PDR RIDS

9006040147

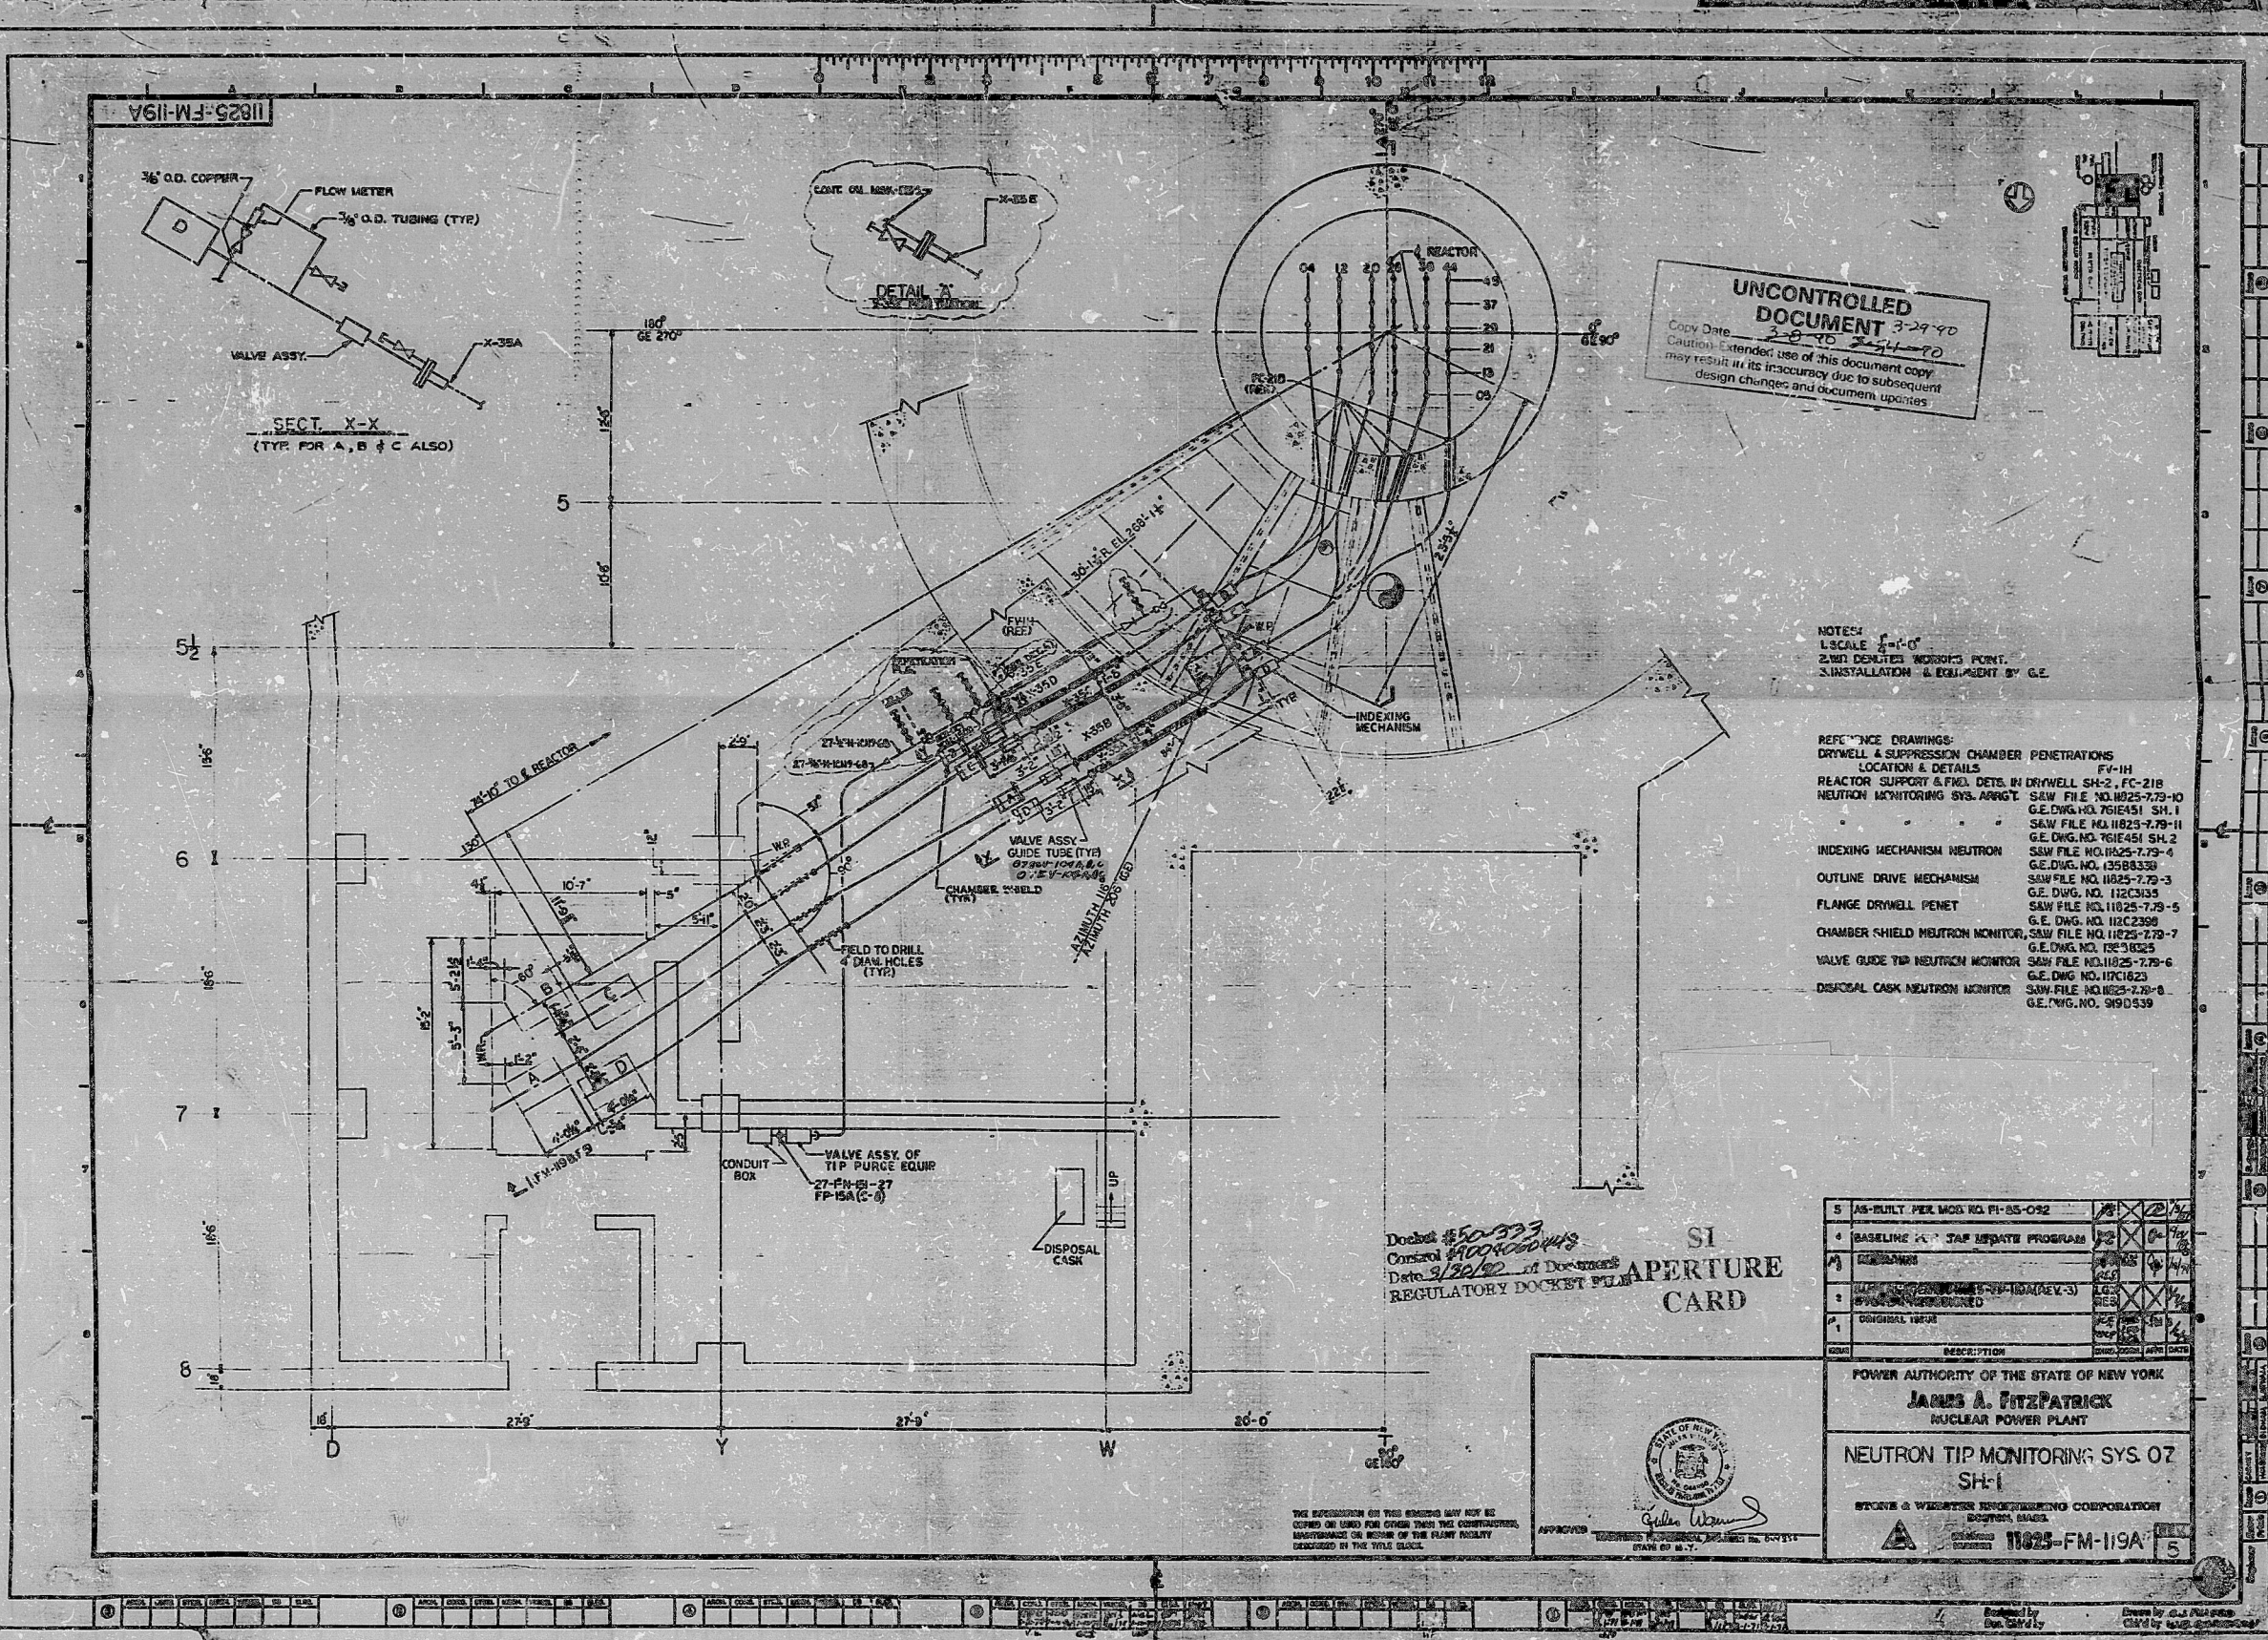
CLASS 1 = PINK
CLASS 2 = YELLOW
CLASS 3 = GREEN
1ST COMPONENT = BLUE
